**ATCO Gas Australia Proposed
Access Arrangement for the Mid-West and
South-West Gas Distribution Systems**

**Review of Technical Aspects of
the Revised Access Arrangement**

**Addendum Report to
Economic Regulation Authority of
Western Australia**

June 2015

Figure 1: Results of ATCO incremental revenue test for overall growth capex

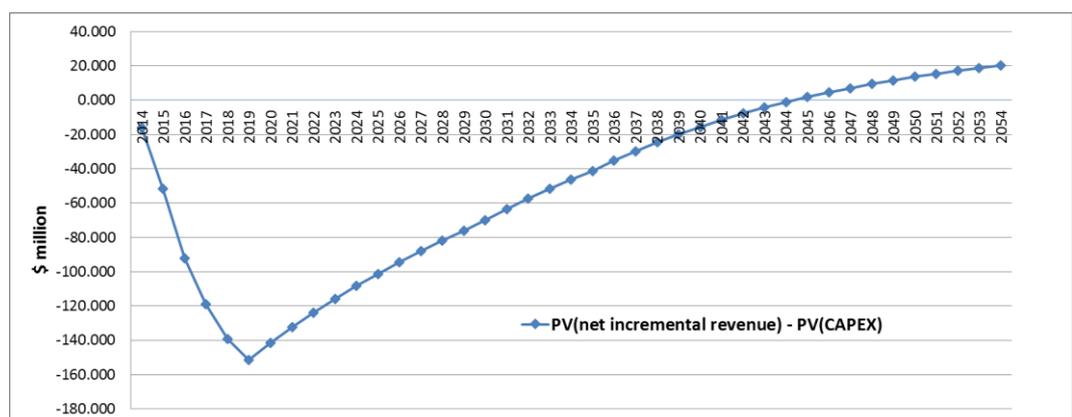
94. We have reviewed the model that ATCO has provided in support of its assessment and we observe the following matters of concern:
- The ATCO incremental revenue model assumes the considerably-modified tariff structure and tariff levels that ATCO has proposed. From 2020 it assumes a 2% per annum decline in those tariffs (in real terms). Rule 79(4)(a), unequivocally in our view, requires that the test uses 'prevailing tariffs'.

Figure 2: EMCa re-assessment of incremental test for overall growth capex after correction for factors identified above

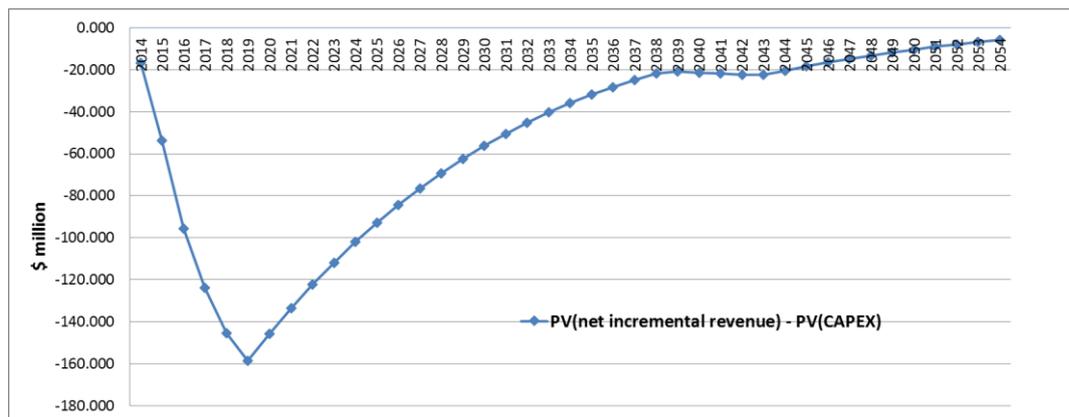
102. The result of modifying ATCO’s growth NPV model to take account of the factors above, is shown in the graph below.

Figure 3: EMCa re-assessment of incremental revenue test for overall growth capex after removal of non-conforming demand projects

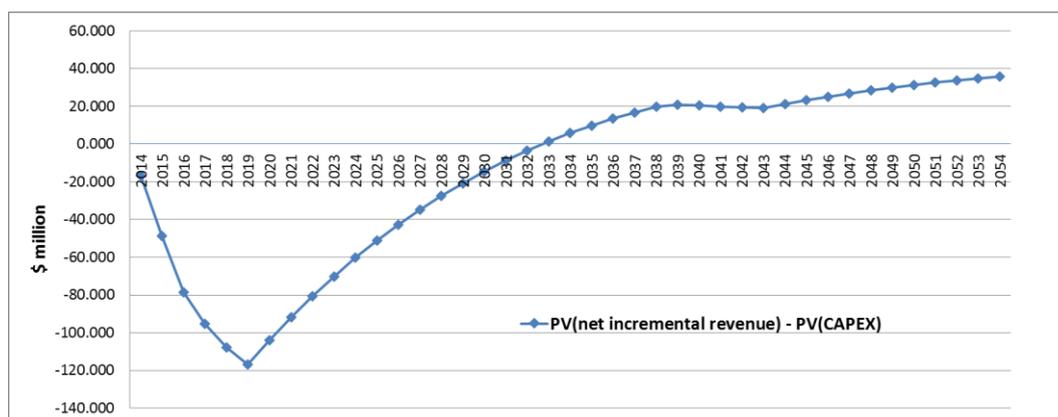
124. Using ATCO's overall growth incremental revenue test model, we have first modified the assumptions as described in section 3.3.4. We have then re-applied the test, modifying the growth expenditure so that it does not include the four demand projects that we consider not to be justified based on their individual NPV tests (as described in section 3.3.6) and the resulting NPV profile is shown in Figure 3.

Figure 5: ATCO's proposed treatment to mitigate supply risk to the northern network

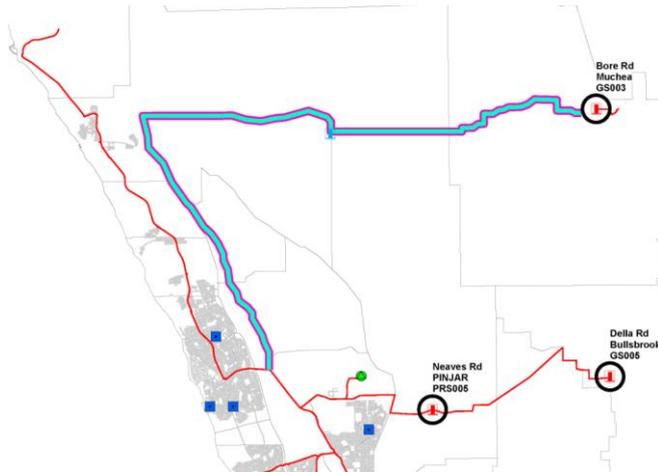
189. On this basis we consider ATCO has an obligation under Safety Case to follow the steps prescribed in table C4 of AS 4645, but it has not done so.
190. ATCO has presented only one option for mitigating the supply risk. We consider that there are number of other pipeline options it could have considered, such as a new shorter pipeline from Bullsbrook GS005 to the southern nominated interconnection point as shown in ATCO Figure 1-4 Appendix 8.2 at notionally half the length of that proposed

191. While noting the very high cost per customer of the mitigation that ATCO has proposed, it is not within our scope to undertake, on ATCO's behalf, the depth of analysis that correct interpretation of AS 4645 requires. In the absence of this analysis, we conclude that:
- (i) ATCO may not have an obligation to satisfy under the NGR (per r. 79(2)(c)(iii)); and
 - (ii) The expenditure that ATCO has proposed to reduce its considered security of supply risk does not satisfy r. 79(2)(c)(i) of the NGR.

Figure 6: ATCO's forecast customers at risk of loss of supply (Two Rocks)

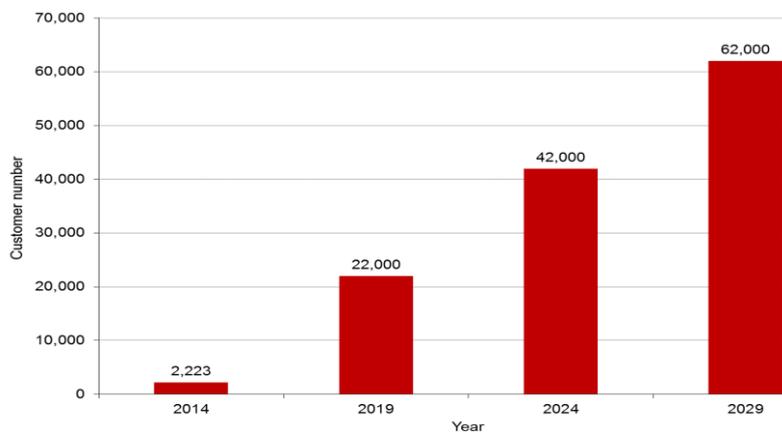
192. We are unable to independently verify that between 20,000 and 22,000 customers in the Two Rocks area will be at risk in the future without assessing both ATCO's detailed modelling⁸⁷ and its demand forecast, both of which are outside of the scope of our review.

194. Assuming that ATCO's analysis is correct and that ~80,000 customers are at risk of loss of supply for failure of either the existing Neaves Rd spur line or the existing pressure reduction station at the Bullsbrook gate station⁸⁸, we consider that this constitutes a *Major* consequence, not a *Catastrophic* consequence as determined by ATCO. This is because ATCO's 25,000 customer risk threshold is not forecast to be exceeded within the AA4 period.

Figure 8: Proposed Pinjarra reinforcement (Option 1)

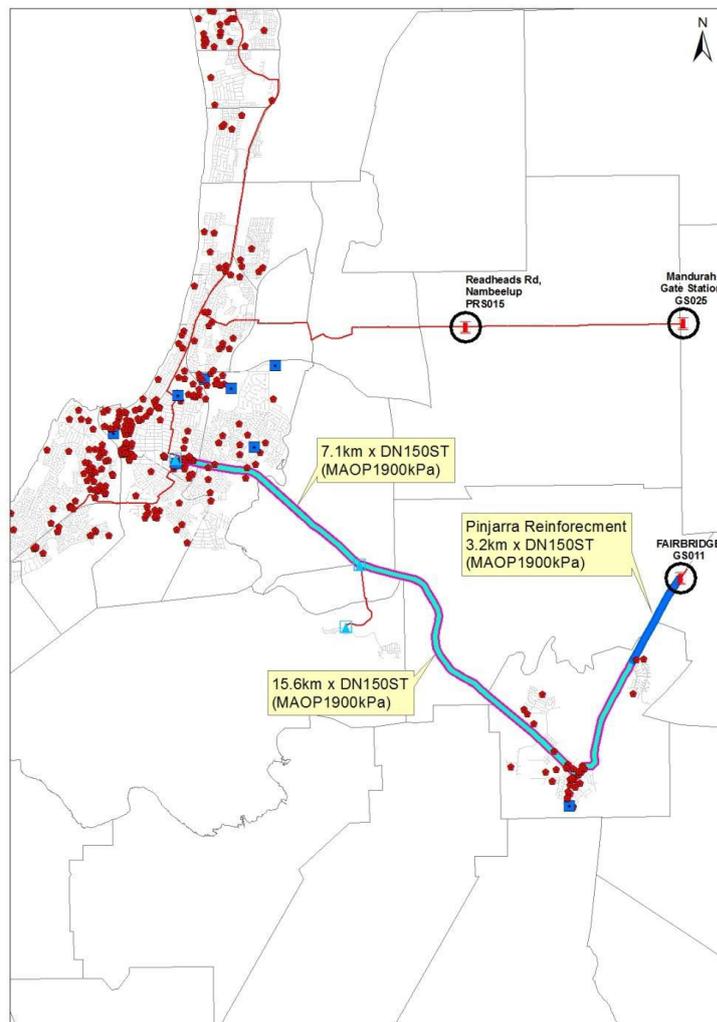
206. ATCO has presented only one option for mitigating the risk, although it does mention that it considered a smaller pipeline diameter of 100mm, but that this does not meet the security of supply requirements.⁹³ We believe other options exist, including procedural controls or, if economically justified, a new shorter pipeline option from Fairbridge GS011 to the nominated interconnection point in the Mandurah distribution system, as shown in ATCO's Appendix 8.2, Figure 1 –6.

207. While noting the high costs per customer of the option that ATCO has proposed, it is not within our scope to undertake the depth of analysis required on ATCO's behalf that we believe correct interpretation of AS 4645 leads to. Further, we consider that the guidelines of the UK Health and Safety executive regarding erring on the side of safety, applies specifically in employing an ALARP assessment for Intermediate risks and in regards to safety-related risks only, and should not be conflated with assessment of and solutions to mitigate other risks. In the absence of the analysis and the lack of evidence that the cost of ATCO's risk reduction measures is not grossly disproportionate to the benefit gained, we find that:
